City of Sioux City
Public Works Department
405 6th Street
Sioux City, IA 51104
November 1, 2016

Addendum No. 1

46th Street Paving and Drainage Improvements
Sioux City, Iowa
OA Project No. 013-0667
6569-719-133

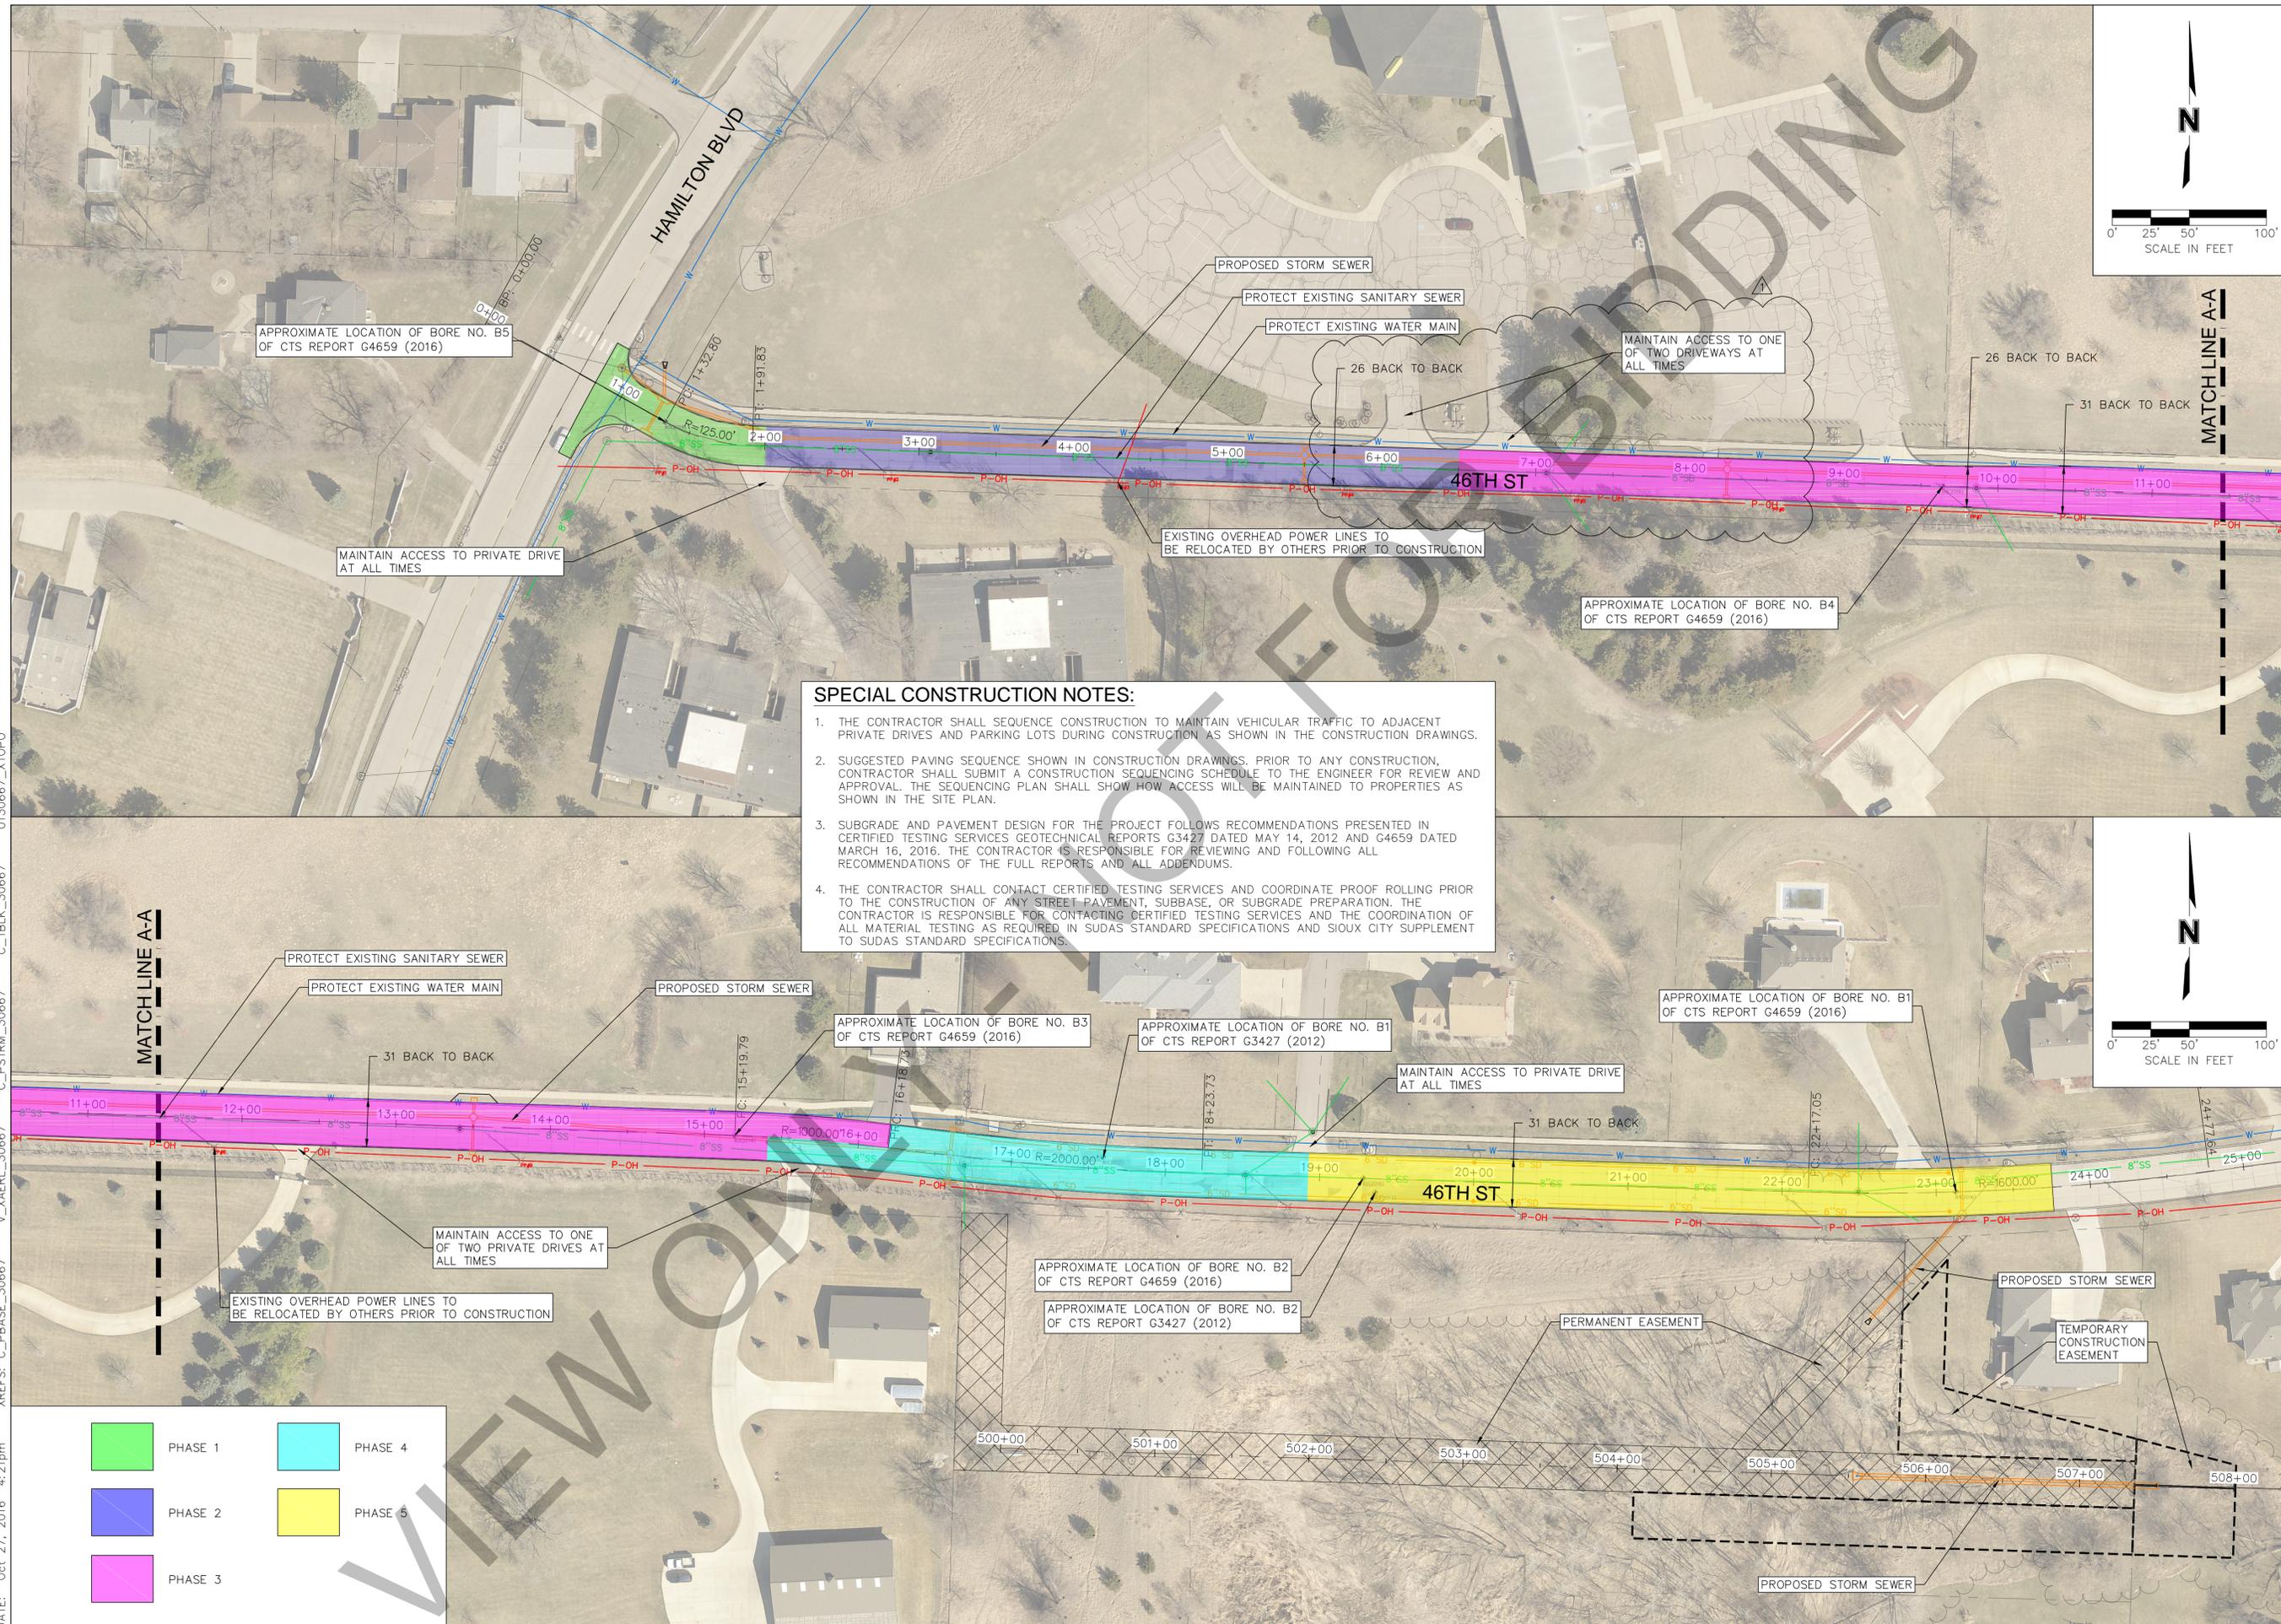
1. Sheet 3 – Site Plan
Adjust the Phase 2/Phase 3 boundary from Station 8+75 to Station 6+50.

REV. NO.	DATE	REVISIONS DESCRIPTION
1	10.27.16	ADDENDUM 1
